AGENDA

September 26, 2019

PLANNING COMMISSION MEETING

5.2. NIPA PCL 47A - Cokeva Parcel Map & DAA - 9000 Foothills BI - PL19-0152

Figure 3
Spatial Variation of Cancer Risk (*per million*)

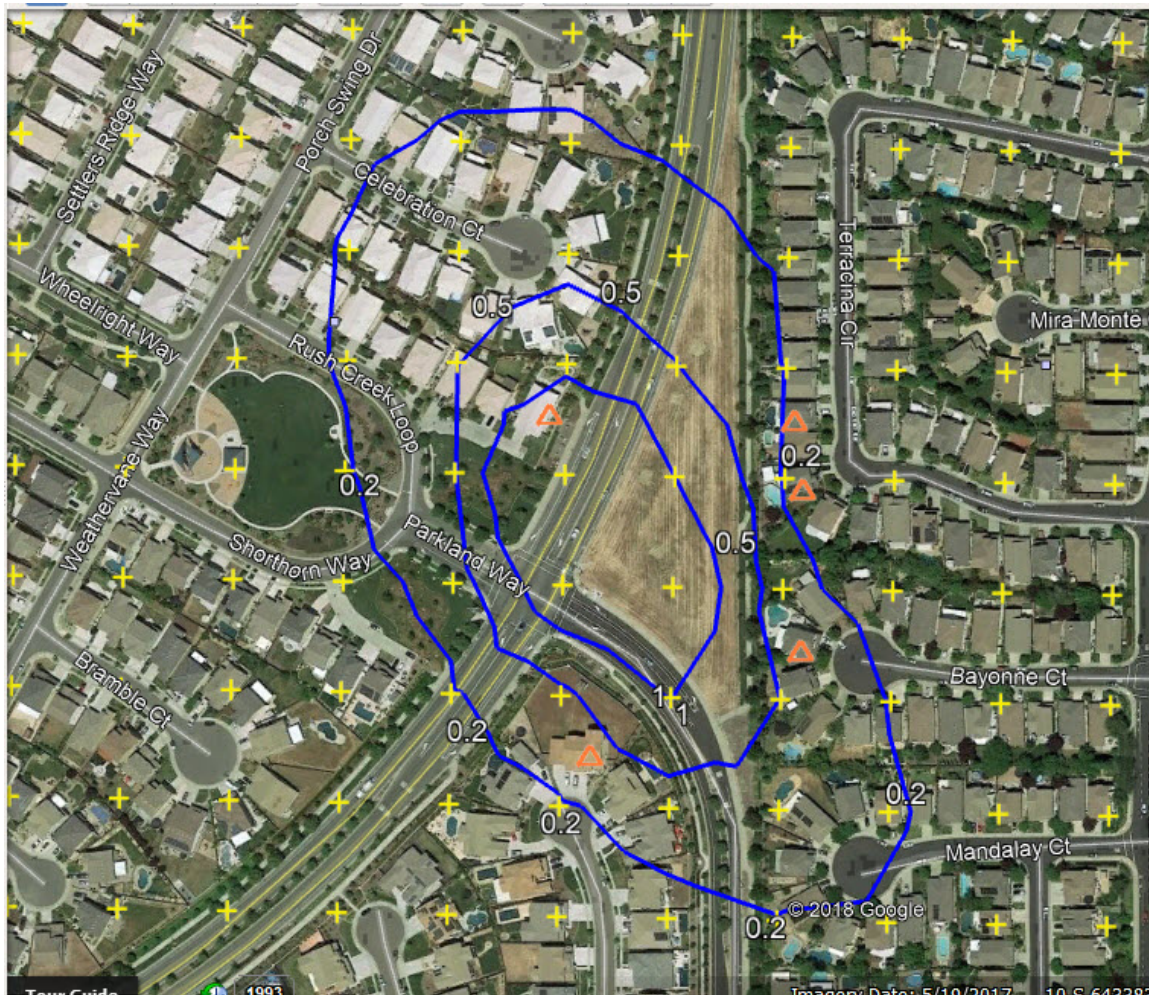
A review of the spatial distribution of cancer risk (Figure 3 FTM) shows that the highest residential risks occur approximately 75 meters northwest of the project. These are residences between the risk contours labeled 1.0 and 0.5 cancers per million. Since Figure 3 provides only an approximate estimate of cancer risk, a second set of receptors were used to pinpoint the risk at individual residences. These receptors appear as triangles in Figure 3 of FTM. Based on the cancer risks at these residences, it was determined that the maximum residential cancer risk occurs 75 meters NW of the project. Cancer risk at all other residential locations is lower than the risk at this location.

3. **Questionable interpolation of health risk.** Figure 3 in the FTM (magnified in Figure 5 in this evaluation), which shows the spatial distribution of cancer risk, is not trustworthy, because the numerical grid is too coarse to capture potential nonlinearities in cancer risk in the vicinity of a gas station. This also explains why increased cancer risks close to emission sources (due to spatial variations in benzene levels as illustrated in Figure 4 for a different gas station) are not recognizable in Figure 3 in the FTM. Figure 3 in the FTM is likely based on some sort of interpolation (perhaps linear), which cannot capture nonuniform benzene levels such as the ones shown in Figure 4. One cannot expect this interpolation scheme to capture adequately the potentially increased cancer risks in adjacent residences.

To address this possibility, EPS re-modeled the risk using a grid size of 20 meters (versus 50 meters used in the FTM Figure 2). Under this scenario, a 100 meter x 100 meter square would have 25 receptors (versus 4 receptors used in the FTM Figure 2). Our analysis shows that the spatial distribution of cancer risk is virtually identical when using the finer grid. The maximum residential cancer risk still occurs at the same location as identified in the FTM Figure 2. See Exhibit A for a side by side comparison of the risk distribution.

Figure 1: Numerical grid used in the FTM. This figure magnifies a relevant portion of Figure 2 from the FTM.

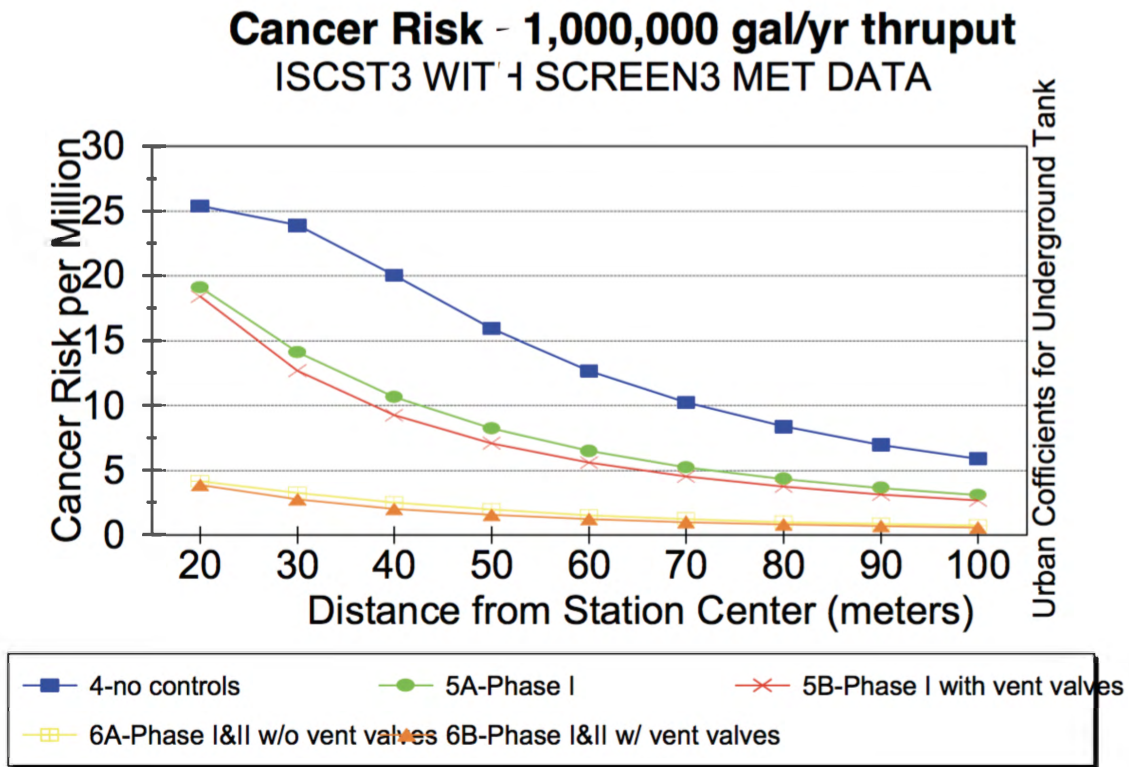
1. **Numerical grid is too coarse.** The authors used a numerical grid, which is too coarse at locations where exposures can be expected to be highest, i.e., on the gas station property, at its fence line, and at adjacent residences. Specifically, the authors used a square grid with a spatial resolution of 50 m. With the current resolution, for some residential properties benzene exposure and cancer risk are modeled only at a single location (see Figure 1). This approach does not account for the fact that residents spend time at different locations of their property. However, for several nearby residential properties, benzene exposure and cancer risk are not modeled at all.

Moreover, the very coarse grid is inadequate to capture nonlinear changes in atmospheric benzene concentrations and associated health risks. As an example I show in Figure 2 modeling results by the California Air Resources Board (CARB) that illustrate the rapid change in cancer risk as a function of distance from a gas station (CARB, 1997). Instead of choosing a modeling domain that is $24 \times 50 \text{ m} = 1.2 \text{ km}$ wide, the FTM should have resolved the spatial variations in health risk at a higher spatial resolution (and it would have been reasonable to do so in a smaller modeling domain).
